**STAFF REPORT  
FOR THE HISTORIC REVIEW BOARD**

**FILE NUMBER:** DR-12-17

**REQUEST:** Opening Enlargement and Reduction, Porch Alterations

1562 Buck Street

1562 BUCK STREET  
FRONT ELEVATION

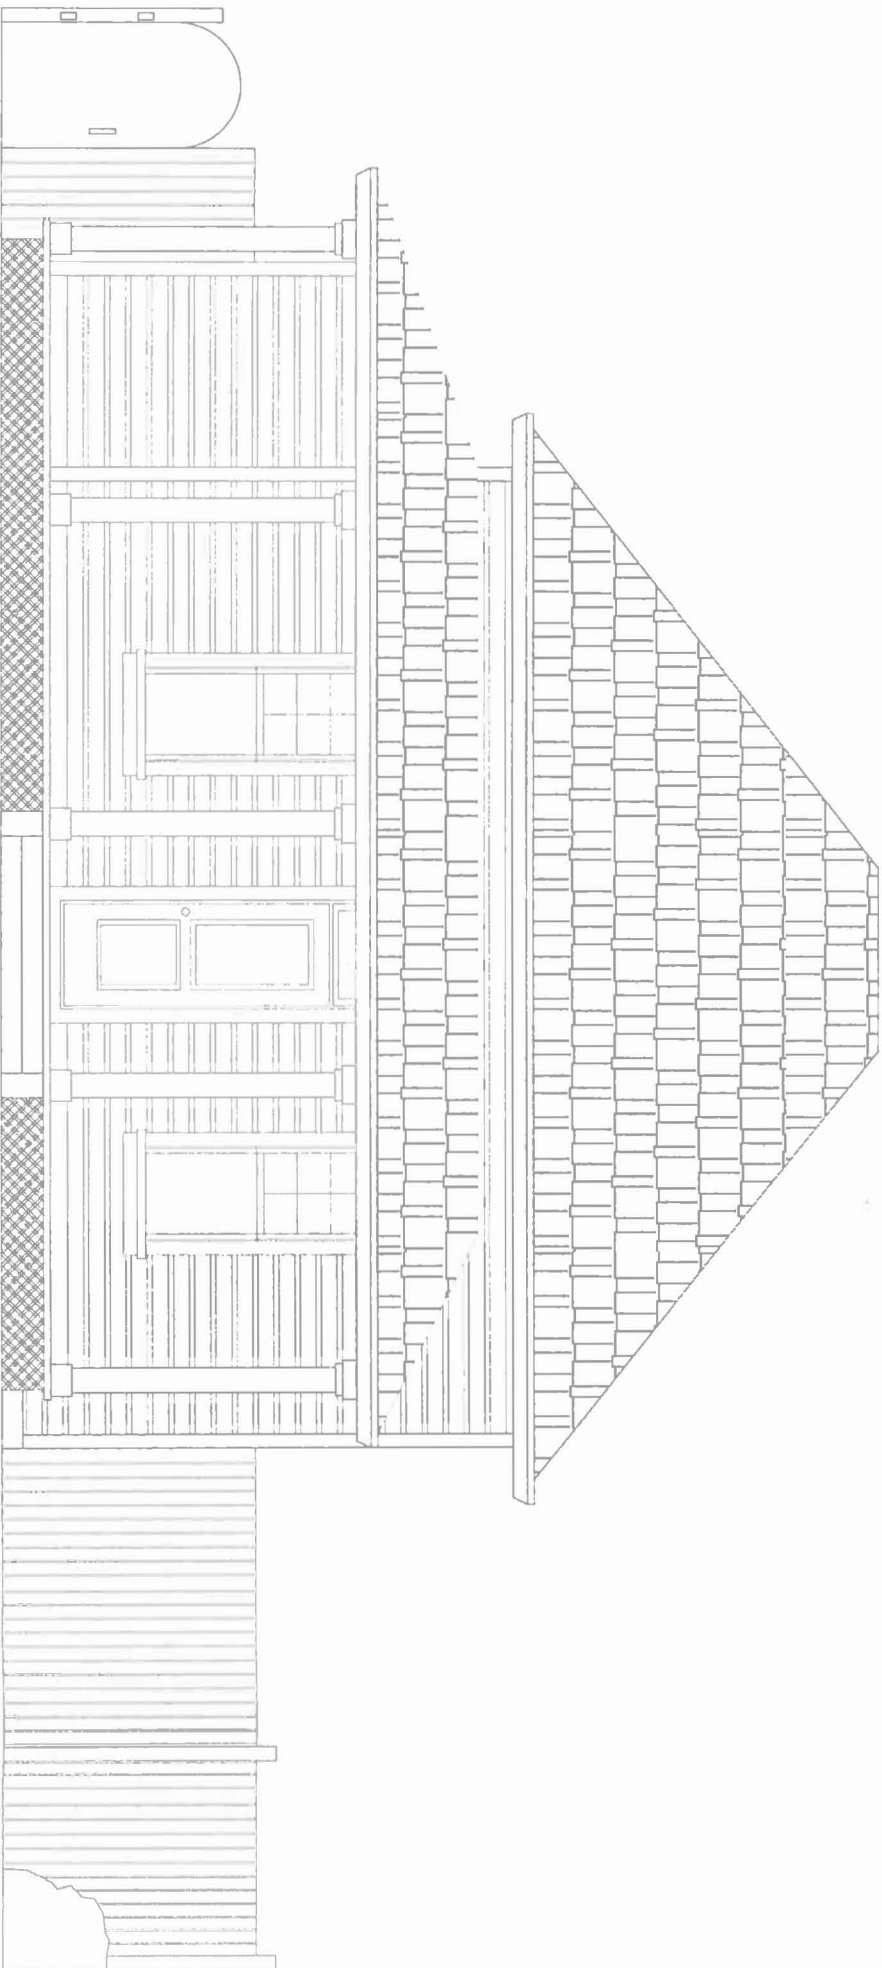
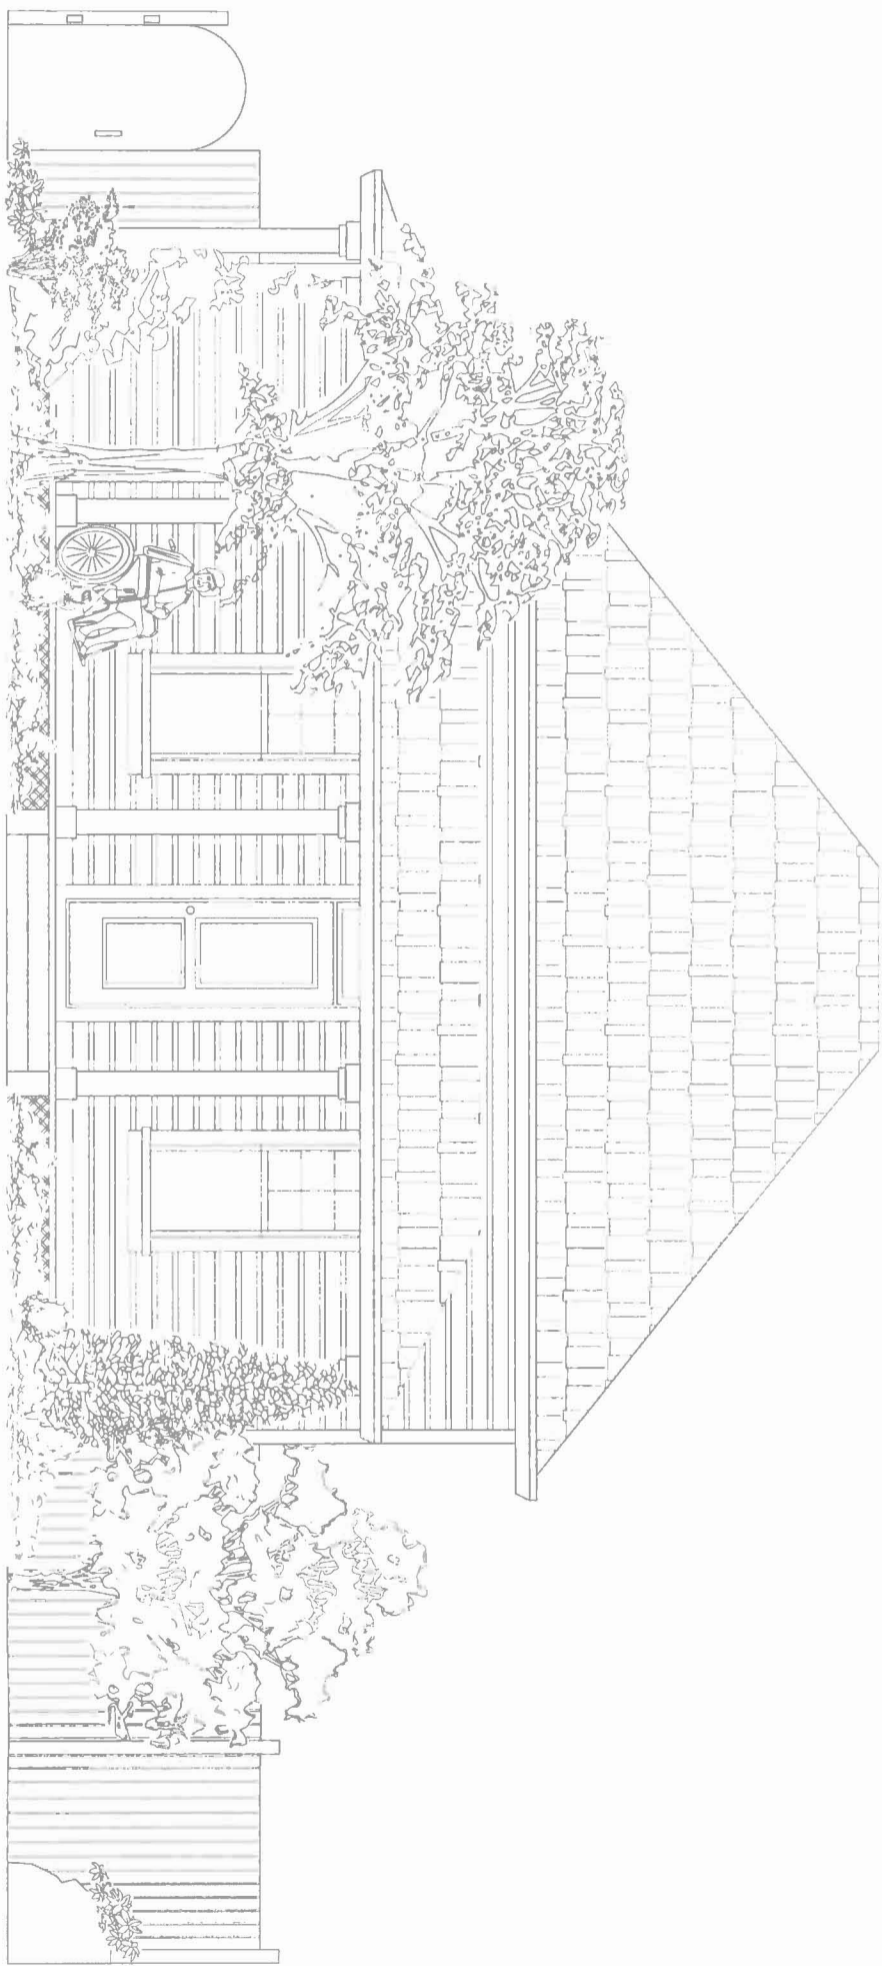
The applicant is also proposing to physically and visually bolster the front porch columns. The columns appear to be historic and staff recommends retaining the existing columns or replacing them in kind rather than altering their appearance.

The porch columns appear to be historic elements on the structure. They both appeared on the 1984 and 2009 historic resource inventories (Exhibit HRB-4). Staff considers these to be character defining features of the vernacular residence and recommends repair and replacement in-kind rather than altering their appearance, which is addressed in recommended Condition of Approval 3.

**FINDING 2:** The applicant is proposing to replace the porch columns. Staff recommends retaining this feature. This is addressed in the recommended Condition of Approval 3.

1. Site Plan, Elevations, and Narrative. The project shall conform to the plans, elevations, and narrative submitted in Exhibit HRB-3, with the exception of modifications required by the following conditions.
2. Windows. The replacement window sashes shall be wood, fiberglass, or another material that exhibits similar visual qualities, subject to Planning Department approval.
3. Porch columns. The porch columns shall be the same size and shape of the historic columns.

1562 BUCK STREET  
SOUTH ELEVATION

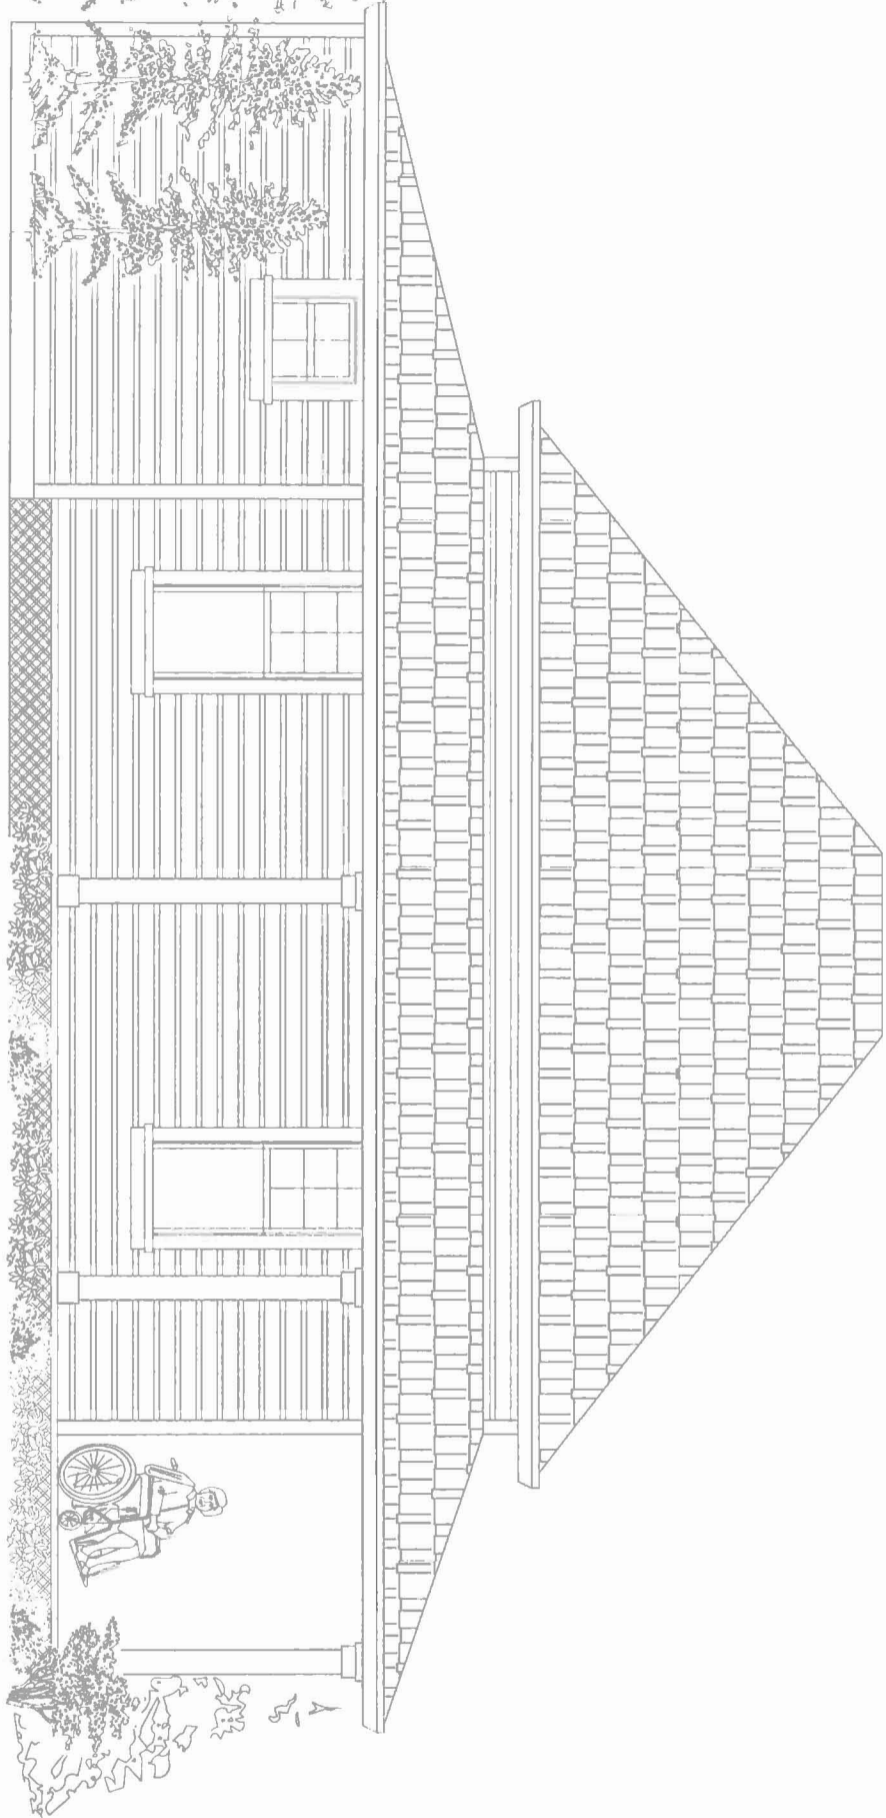
**FINDING 1:** The applicant is proposing to remove or enlarge several openings on the structure and alter the front porch columns. In terms of the openings, they are on secondary facades and a rear addition, and are not easily visible from the public right-of-way. Their removal or alteration would not significantly impact the character of the structure. In addition, the historic windows have been replaced with vinyl windows and with recommended Condition of Approval 2, the applicant would install wood or other windows with visual qualities that would more closely match the originals, which would return some of the original character to the structure.

**FINDING 7:** The applicant is proposing vinyl windows, which do not have the same visual qualities as wood windows. Staff addresses this in the recommended Condition of Approval 2.
